Vallis Way Definitive Plan Responses

**Vallis Way
Lynnfield, Massachusetts**

RE: Vallis Way / Caggiano

The following is a response to the September 2, 2021 Linden Engineering report to the Town of Lynnfield Planning Board as it relates to the 109 Lowell Street / Vallis Way Definitive Plan Subdivision filing.

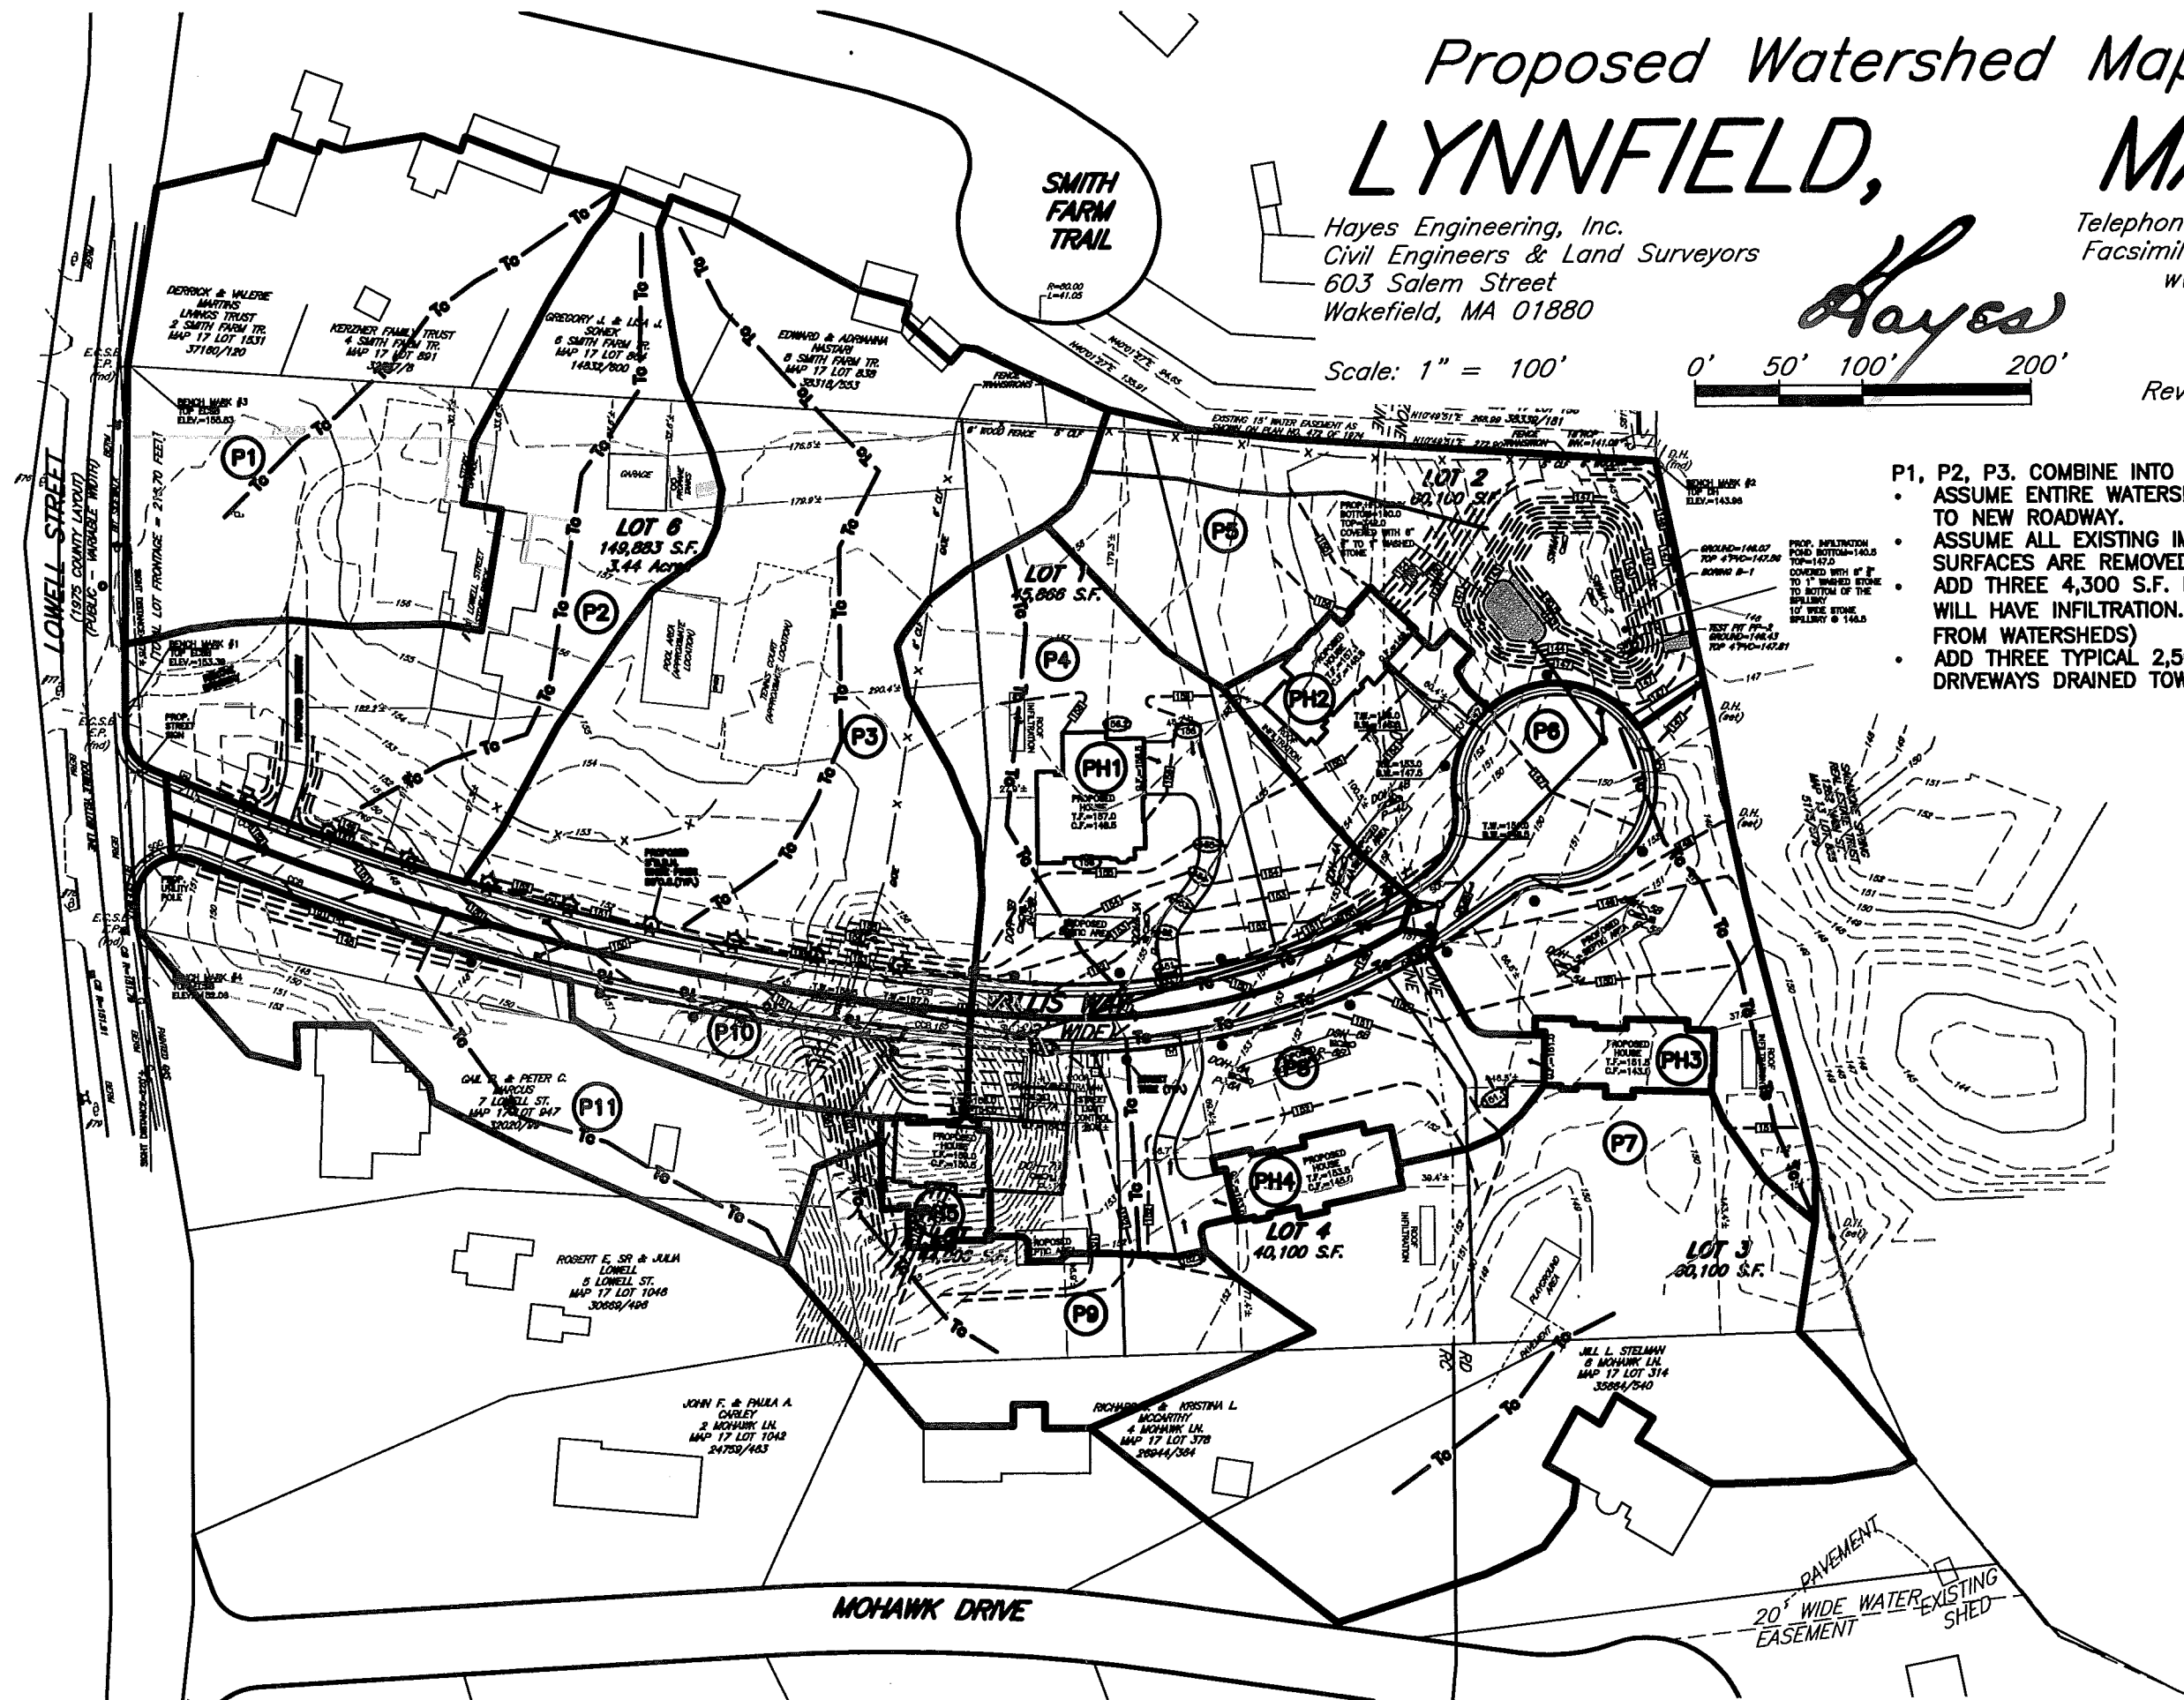
- P1, P2, P3. COMBINE INTO ONE WATERSHED
- ASSUME ENTIRE WATERSHEDS WILL GRADE TO NEW ROADWAY.
- ASSUME ALL EXISTING IMPERVIOUS SURFACES ARE REMOVED.
- ADD THREE 4,300 S.F. HOUSES WHICH WILL HAVE INFILTRATION. (SUBTRACT FROM WATERSHEDS)
- ADD THREE TYPICAL 2,500 S.F. DRIVEWAYS DRAINED TOWARDS ROADWAY.

Second, the Planning Board has requested that anticipated development on the Vallis property be included in the hydraulic calculations (Note: the property itself with its existing development has always been included in the calculations). In order to do this it was presumed that one additional lot would be created on an Approval-Not-Required basis (Note: any additional lots would require the removal of the existing Vallis residence), and that no stormwater management would be included as part of that development. That would result in an additional 4,321 square feet of impervious, including house and driveway.
